UNITED STATES PATENT AND TRADEMARK OFFICE

10/576,099

Office Action Summary	Application No. 10/576,099	Applicant(s) EVANS ET AL.	
	Examiner ALEX W. MOK	Art Unit 2834

DETAILED ACTION

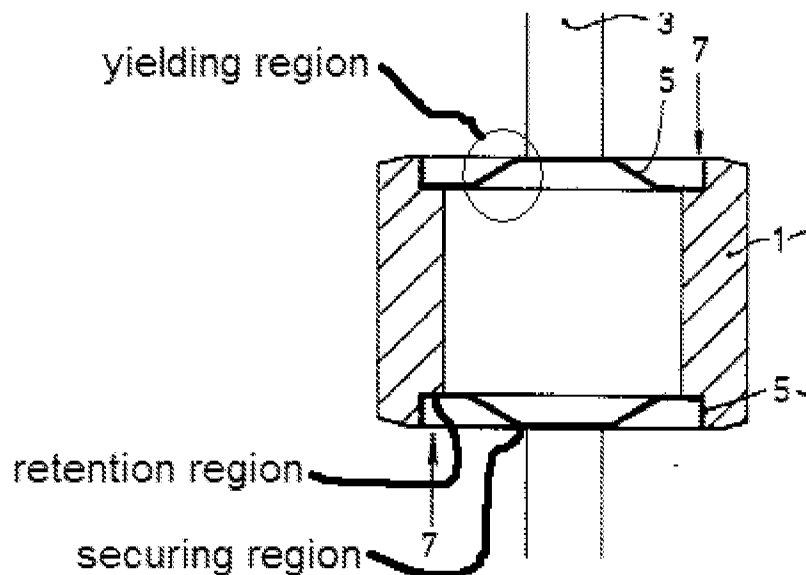
For claim 25, Weiland teaches each said at least one covering disk comprising a yielding region (see figure 1, and figure below).

For claim 26, the yielding region as explained for claim 25 above can constitute a bead extending in the circumferential direction.

For claims 30 and 31, the yielding region as disclosed by Weiland can be considered to be embodied as a connecting region, disposed between a securing region

and a retention region for the magnet element, and wherein the connecting region is inclined to the securing region (see figure above).
